Determination 2006/54

Safety barrier to a house deck at 22 Caroline Heights, Omaha Beach, Warkworth

Figure 1: Detailed cross-section through the proposed barrier

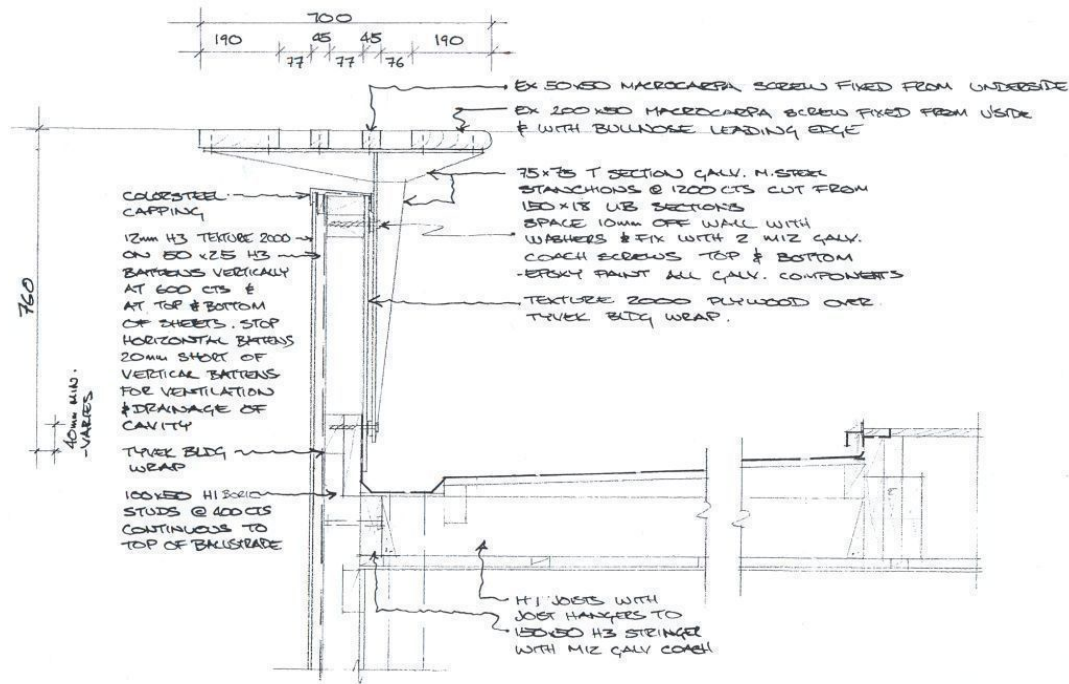
The deck barrier as designed does not comply with the NZ Building Code F4 Safety from Falling. The barrier is to be 1000 mm high or obtain a determination from the Department of Building and Housing that the barrier as designed is in compliance.

- 1) The effective height in a domestic high use situation as a deck is insufficient to stop people including children from falling.
- 2) The flat top of the barrier encourages people and children to both sit and walk on the top of this barrier.

6.4.5 In the draft, I said that I considered that, particularly for children of 4 or 5, the 760 mm barrier, despite the internal overhang with its rounded edge, would not be as difficult to climb as an F4/AS1 barrier.

6.4.7 I have carefully considered that response, but it has not changed my conclusion that the 760 mm barrier would not be as difficult to climb as a 1,000 mm F4/AS1 barrier. In particular, I am not convinced that children in the 3 to 6 age group, when faced with the challenge of climbing a barrier, can in fact be relied on to make the rational judgments envisioned by the owners. I do not accept that such children would need something to stand on in order to climb the barrier given that most such children can climb a 1,000 mm F4/AS1 compliant design.

7.1 For the reasons set out above, I conclude that the barrier does not comply with the Building Code in respect of restricting the passage of children.

- 8.1 In accordance with section 188 I hereby:
- (a) Determine that the barrier does not comply with clause F4 of the Building Code.
 - (b) Confirm the territorial authority's decision to refuse to issue the code compliance certificate.
